CACTUS BLUFF OF STONE OAK MDP AMENDMENT
 TO POADP PLAN # 388

Department of Development Services

Re: **Cactus Bluff Amendment**

MDP # 388-A

PRELIMINARY OVERALL AREA DEVELOPMENT PLAN

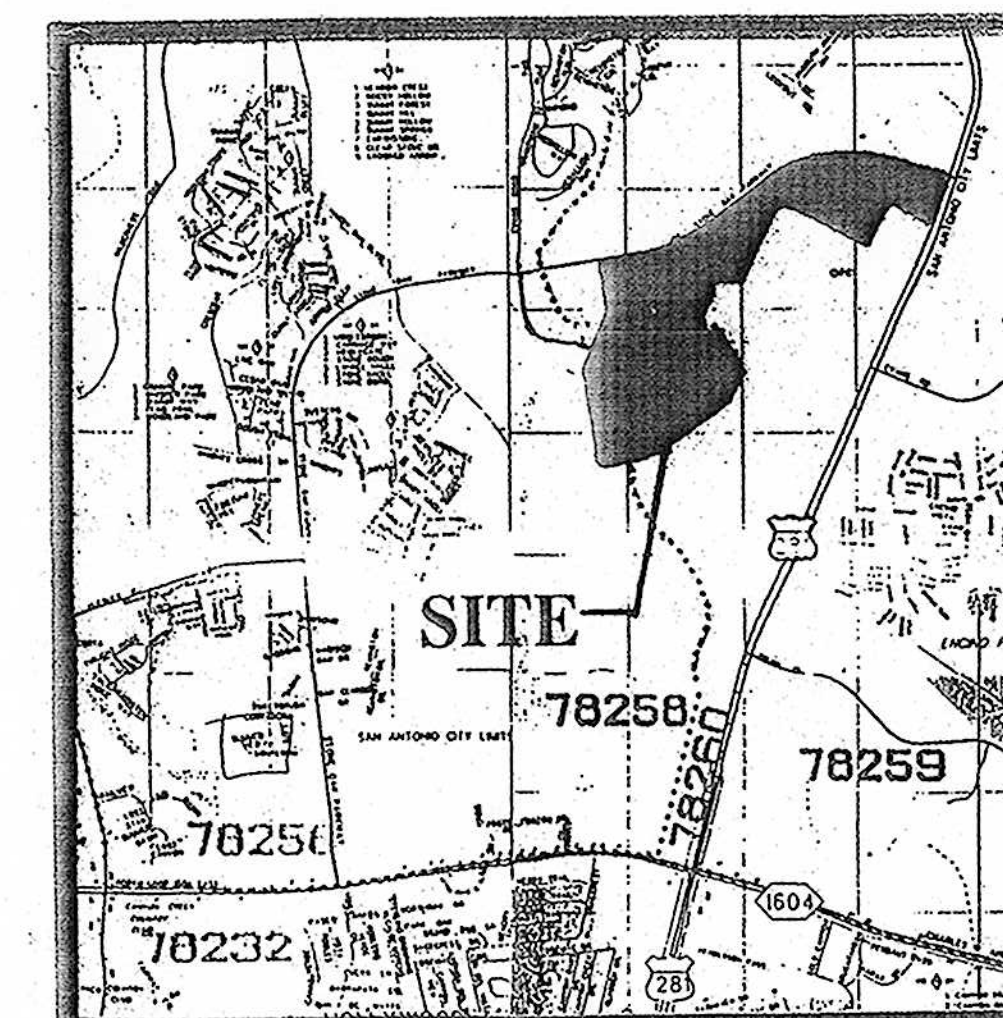
In consideration of public safety and convenience, excessive grades by reason of topography should be avoided in street layouts and arrangements. Any access and R.O.W. issues along state facilities will need to be resolved with the **Texas Department of Transportation (TXDOT)**. For information about these requirements you can contact TXDOT at 615-5814.

All platting shall comply with the Unified Development Code (UDC), Master Plan, Major Thoroughfare Plan, and all applicable regulations for the City of San Antonio. It will be expected that all of the property depicted in your Master Development Plan to include floodplains, drainage areas, and open space shall be platted. It is suggested to work closely with the school district, so they can plan accordingly.
